AMENDMENT TO THE DRAWINGS:

Serial No. 10/767,634
Amdt. Dated 4-4-06
Reply to Office action of 12-21-05
Annotated Sheet Showing Changes

Fig. 1a

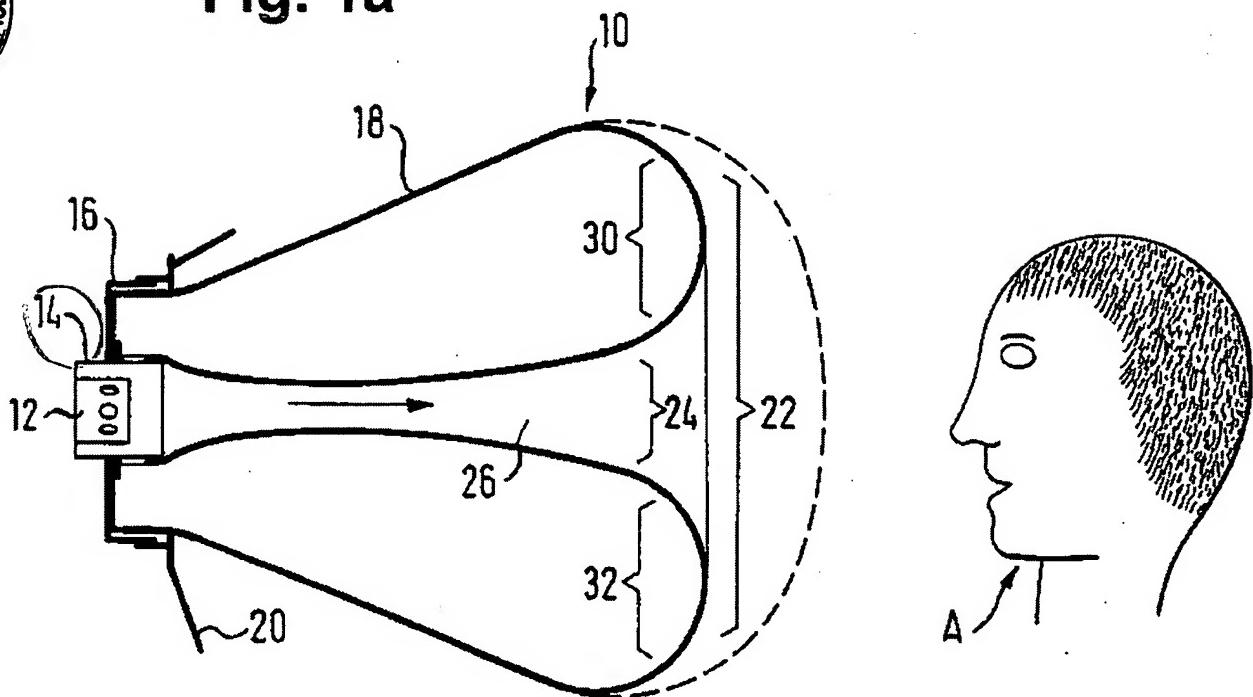
The attached replacement sheet of drawings includes changes to Figs. 1a and 2. Specifically, Fig. 2 is amended to replace the reference numbers "R1" and "R2" with --R5-- and --R6-- for Fig. 2. The lead line for the diffuser in Fig. 1a is corrected. Fig. 3 is added to show the feature recited in claim 3. Annotated drawing sheets showing the changes in red are also attached. No new matter has been added.

Fig. 2 is amended to replace the reference numbers "R1" and "R2" with --R5-- and --R6-- for Fig. 2. Accordingly, the specification is amended to reflect this change to Fig. 2. The lead line for the diffusor in Fig. 1a is corrected. Fig. 3 is added to show the feature recited in claim 3 that the horizontal width of the upper region is greater than the horizontal width of the lower region. This feature is
